**86 Ancton Way
Bognor Regis
PO22 6JP**

**Flood Risk Assessment &
Management of Surface Water Run-off**

**This version:
REVISION B 18.11.2025**

Prepared by	Philip Pitman C Build E MCABE MCIHT MFPWS Chartered Building Engineer
Date	21 st February 2025
Versions: Revision A 23.06.2025: Amended to Arun DC drainage engineer comments. Response letter to Arun DC included in Appendix 9 Revision B 18.11.2025: Amended to address Arun DC drainage engineer comments of 27/10/2025

Drawing status
PLANNING
Scale
PP
Drawing Number
006

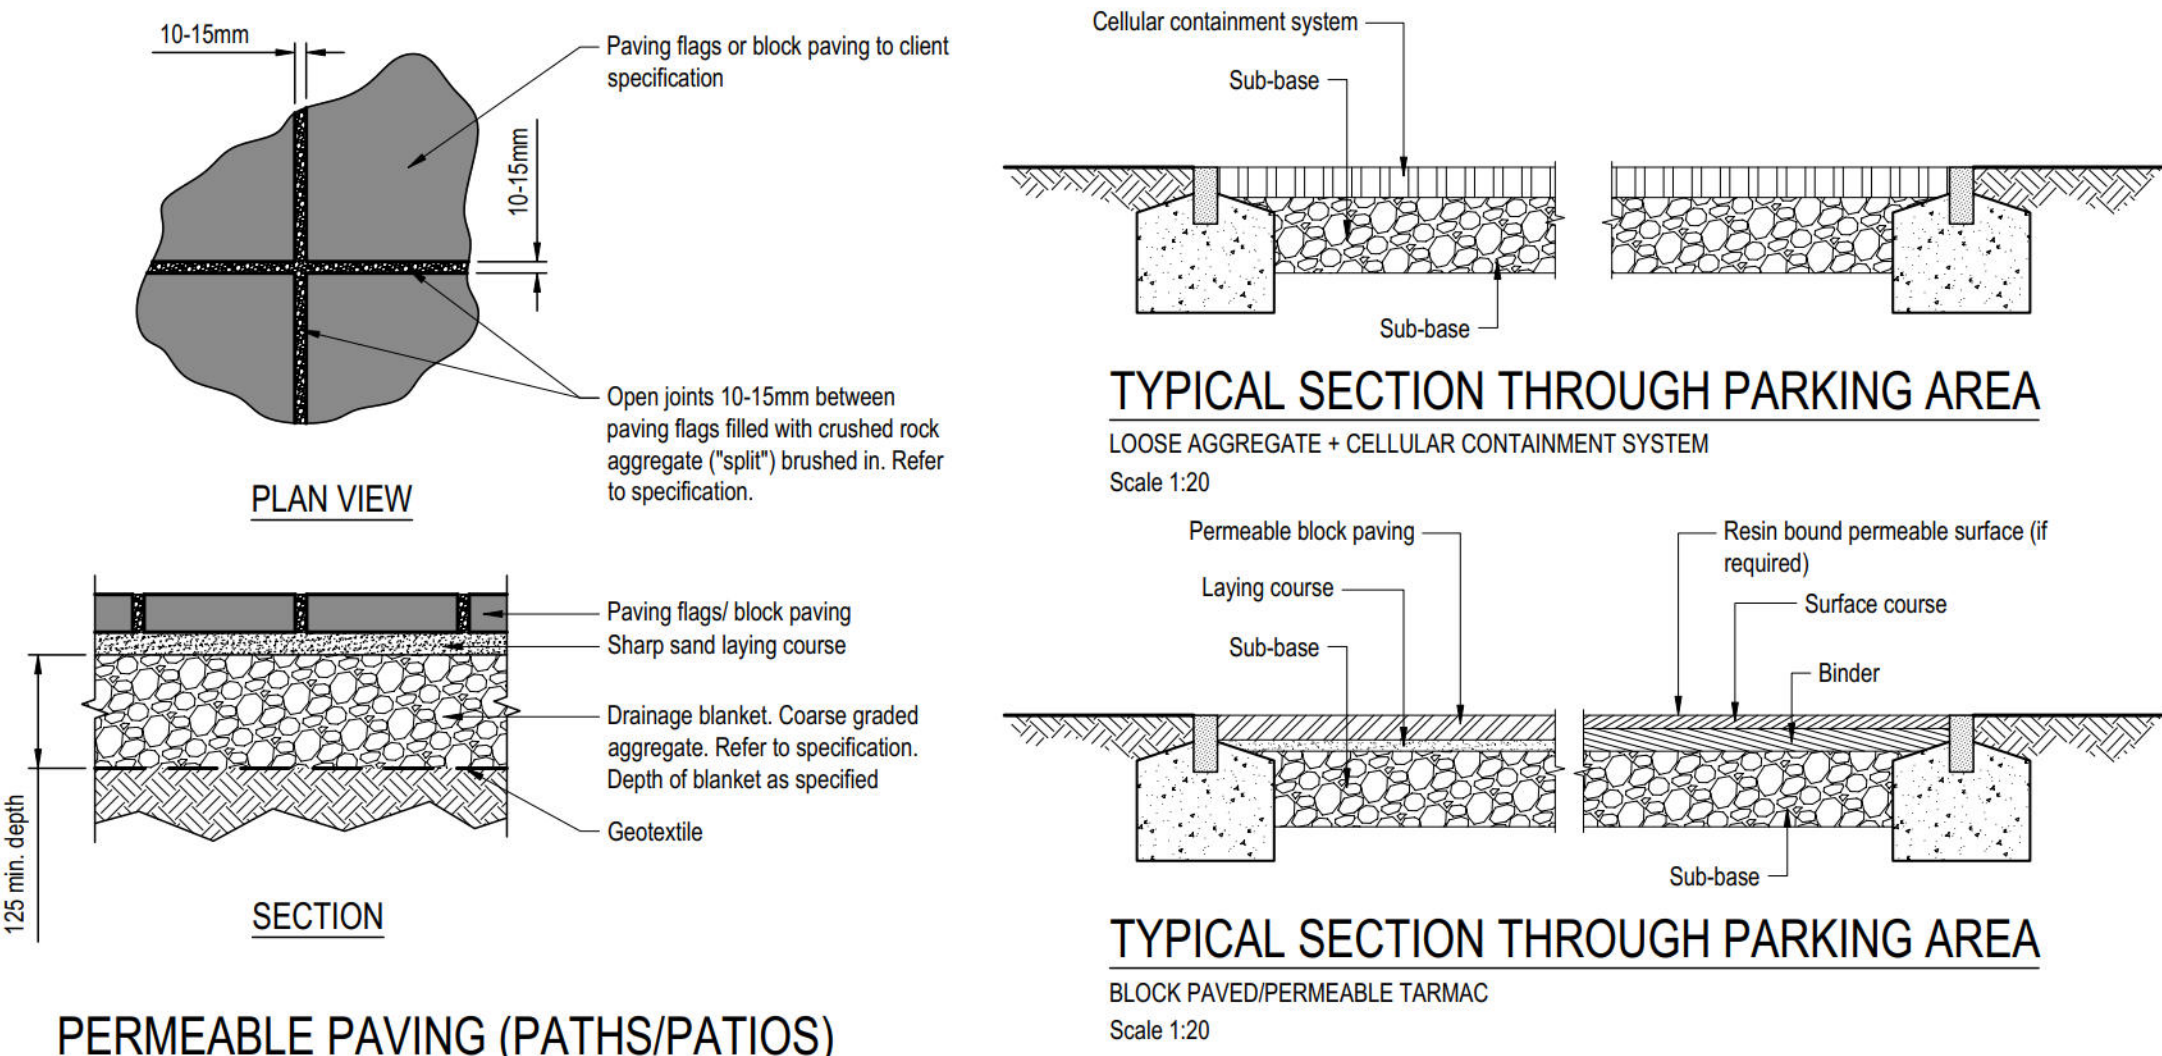
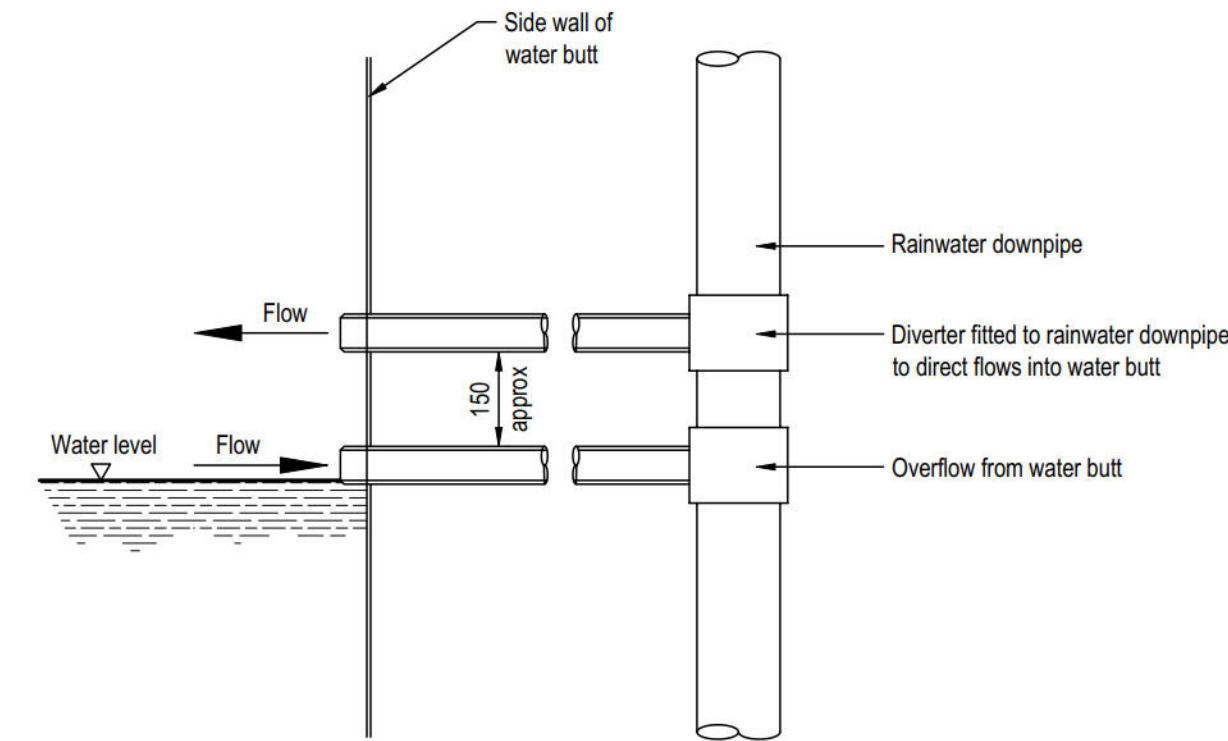
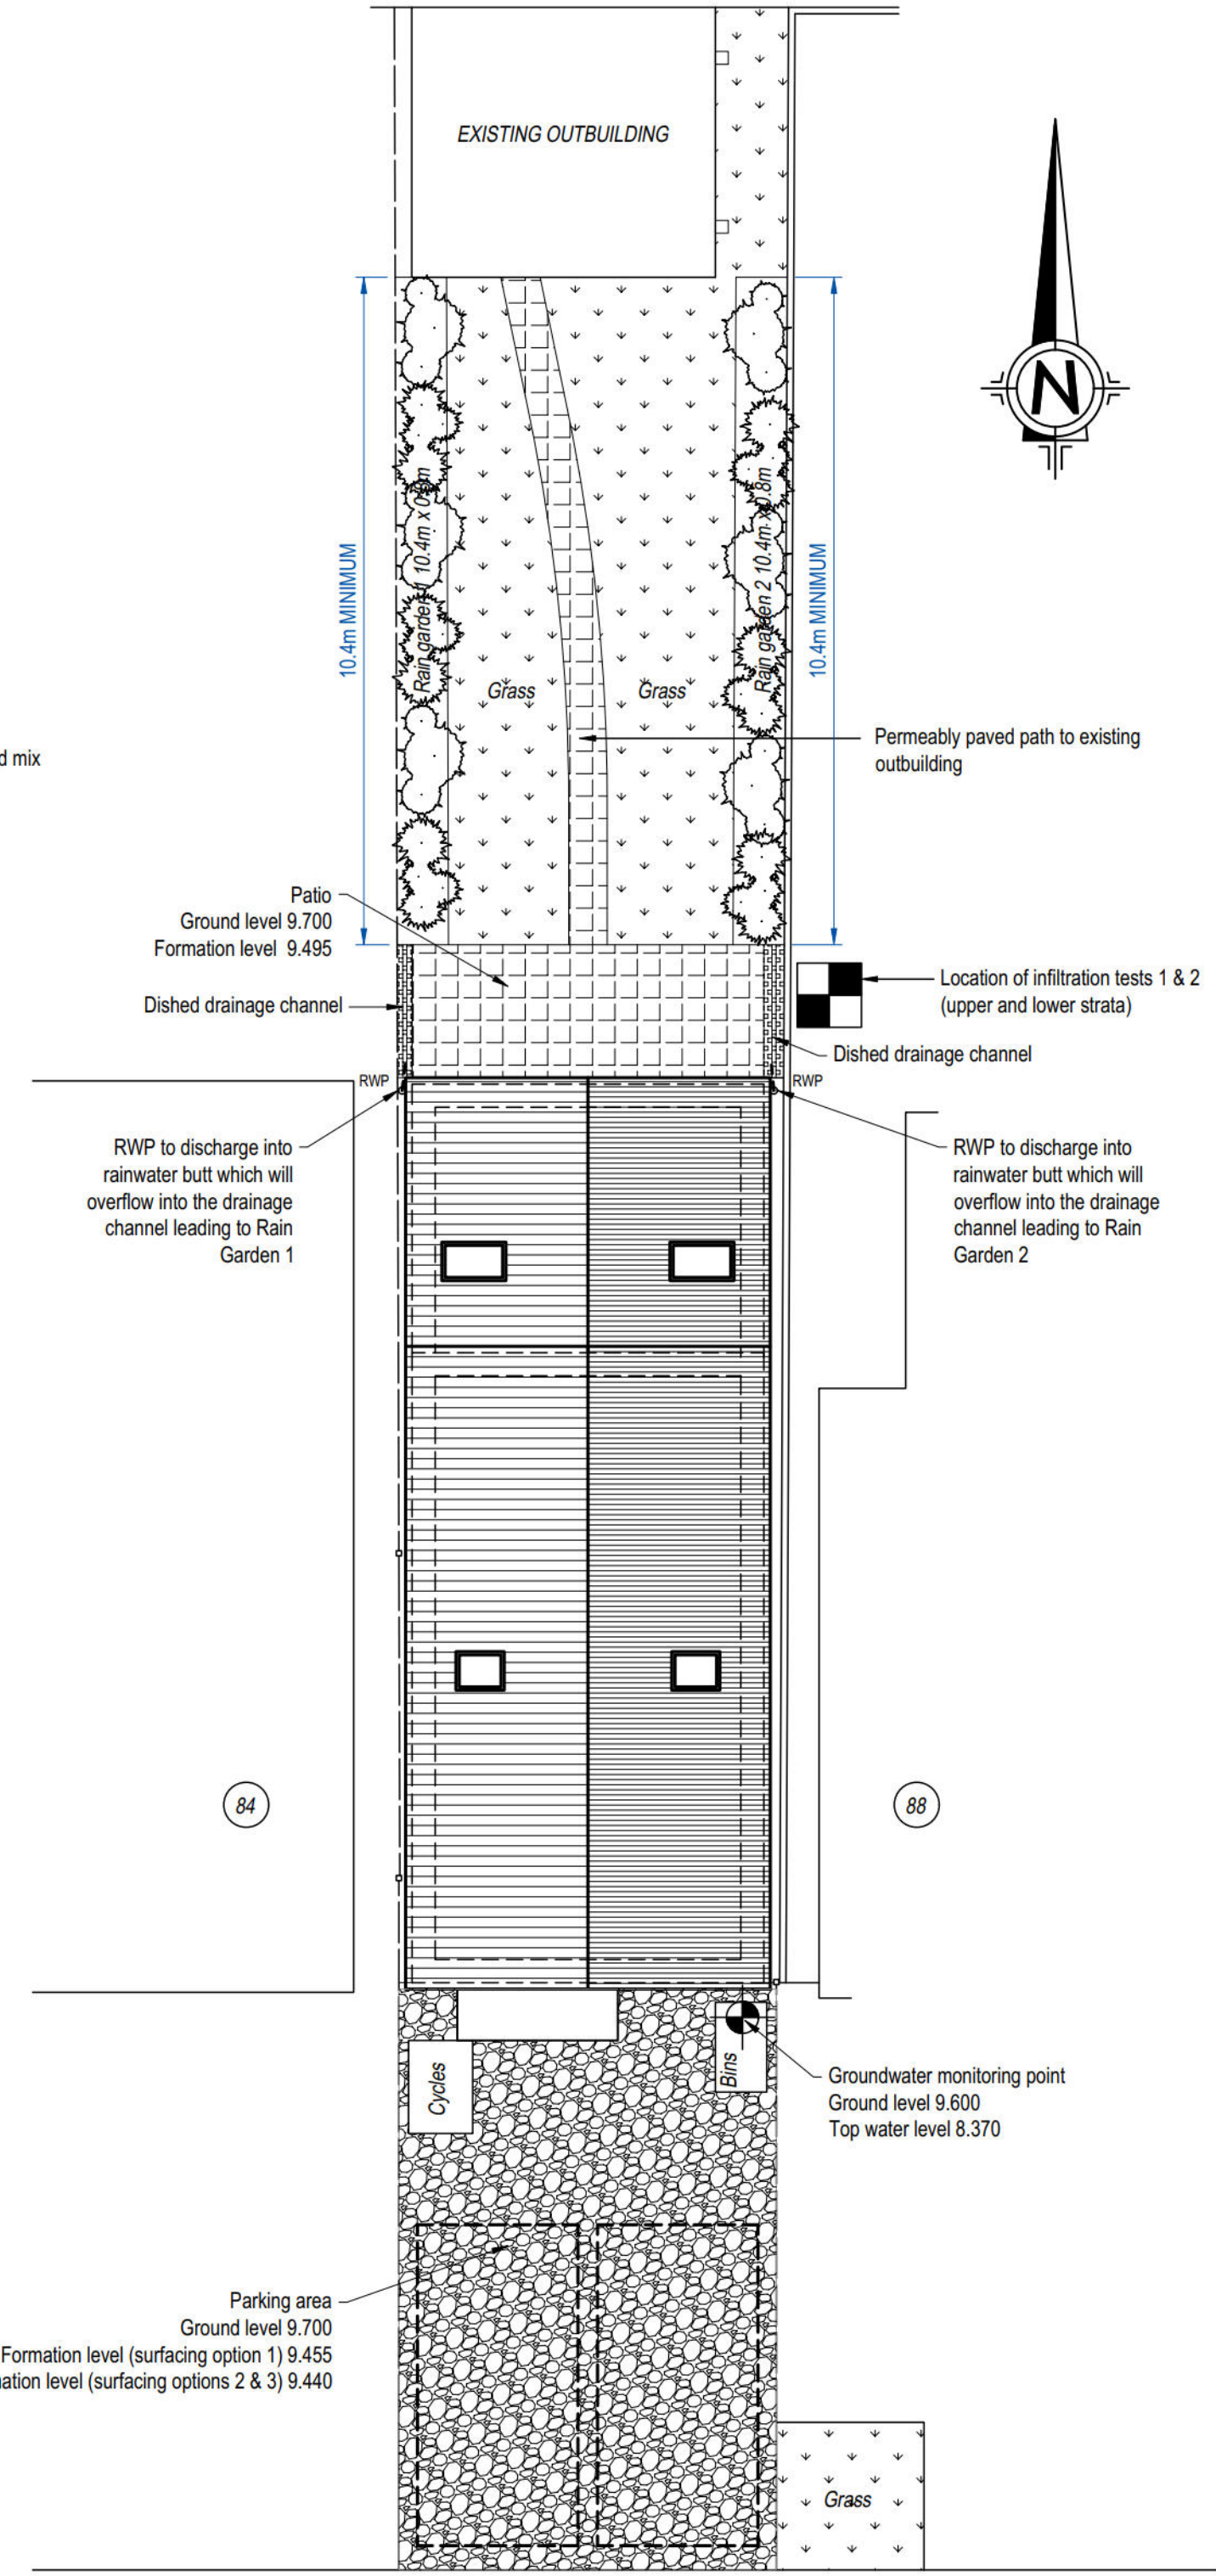
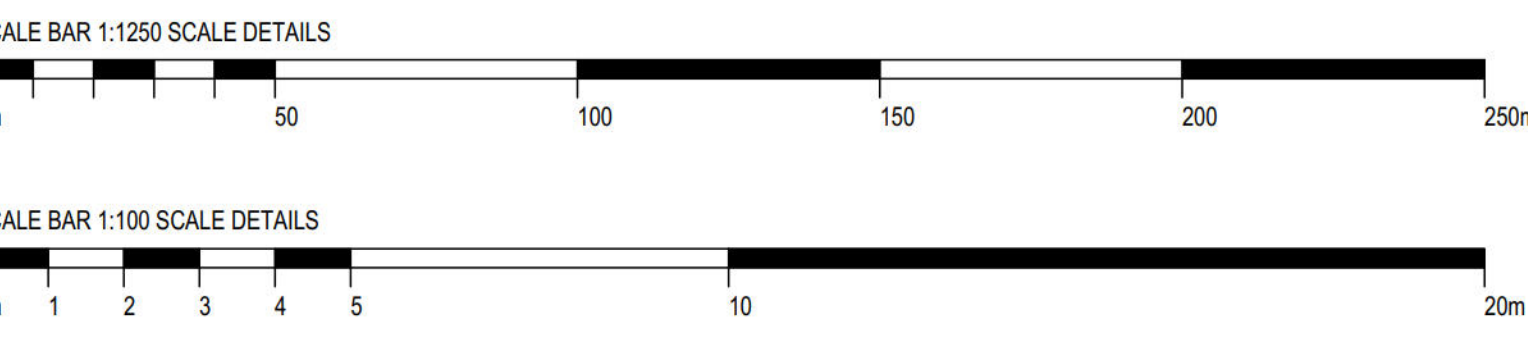
Arun DC comment: *An infiltration design has been proposed. Groundwater levels have been monitored which revealed a peak groundwater level of 1.23m below ground level on the 30th January 2025. The design has tried to ensure that 1m of unsaturated ground is provided between the base of the infiltration structures and the peak groundwater level. However, it is unclear as to whether 1m is truly being achieved based upon the construction depths, particularly for the rear infiltration structure. The construction details for the proposed drainage blanket beneath the patio also does not replicate the proposed aggregate construction depths indicated on the layout plan view. Clarity should be provided by providing peak groundwater levels and formation levels for infiltration devices, to a common datum. AOD would be the preference. The construction details should be adjusted as necessary.*

Arun DC comment: *A plan showing the location of the groundwater monitoring point should also be provided.*

Response: The rear infiltration structure is a drainage blanket beneath the patio area and the thickness of the blanket is 270mm. This 270mm is the depth required to achieve satisfactory hydraulic performance and is greater than the 100mm minimum required to achieve satisfactory structural performance. I have noticed there is a typo on the section detail provided. It states a depth of 370mm. The calculations and the plan both state 270mm. The 270mm is correct. I will correct the section detail. The revised drawing will be issued on 23rd June.

Response: The location will be shown on the revised drawing to be issued on 23rd June
